JURUPA COMMUNITY SERVICES DISTRICT

ADDENDUM NO. 6

TO THE PLANS AND SPECIFICATIONS FOR RECYCLED WATER PROGRAM – SEGMENT 2 FINAL DESIGN JCSD P.N. C215078

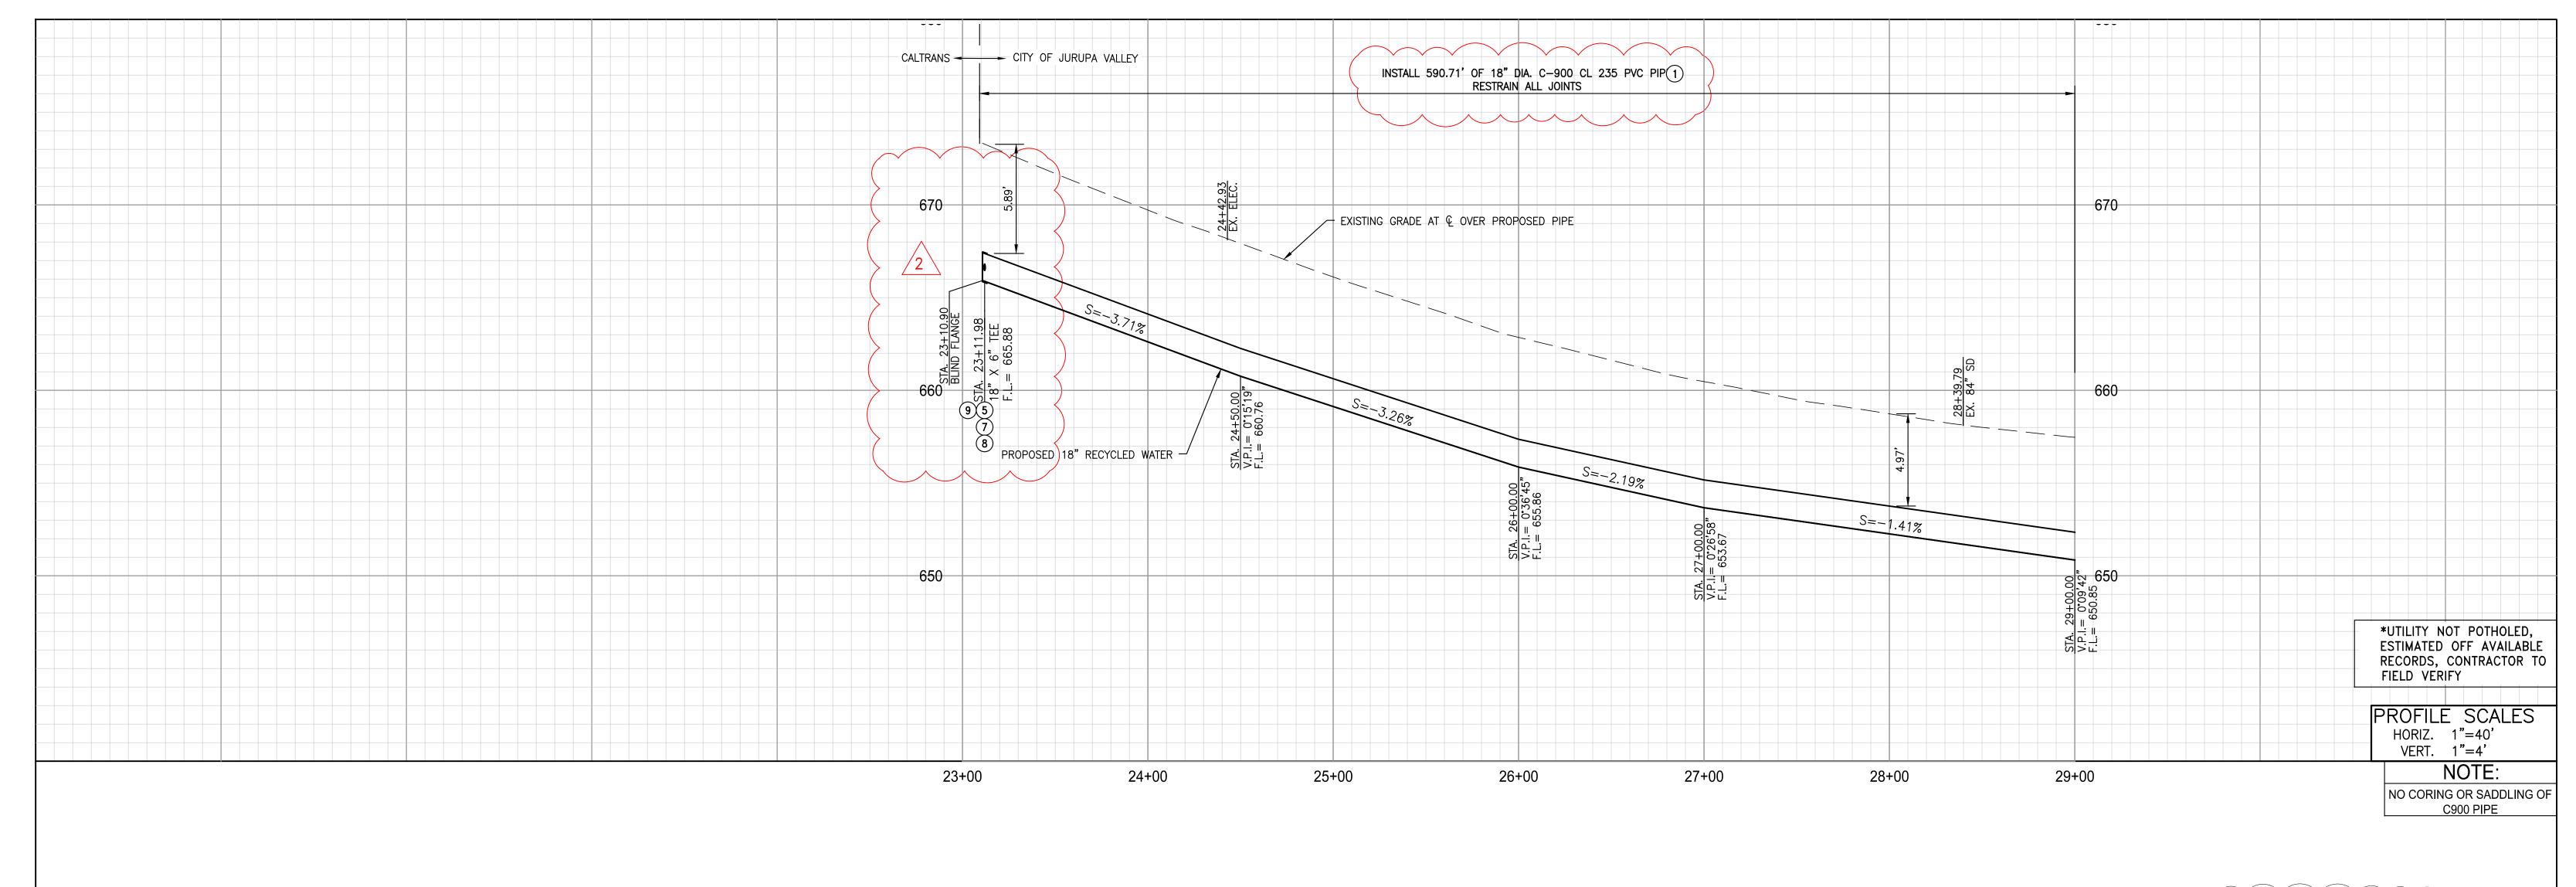
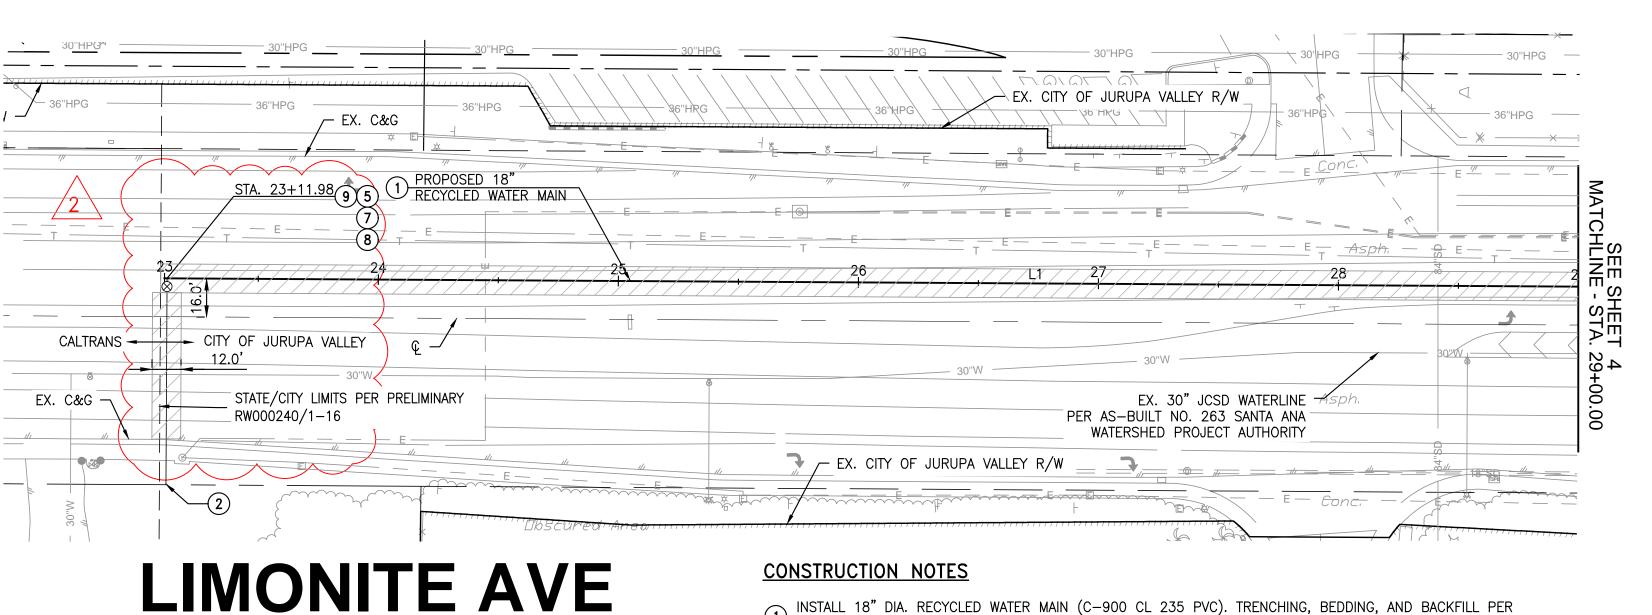
The pipeline design sheets for the Limonite Extension - Sheets 1 through 5 have been revised to exclude work within the Caltrans R/W and the City of Eastvale R/W.

> SLB 4/17/25 ADDENDUM NO. 3 REVISION LABELING BID SCHEDULE SLB 5/23/25 ADDENDUM NO. 6 REVISION TO ALIGNMENT APPR. DATE MARK | BY |DATE REVISIONS **JCSD**
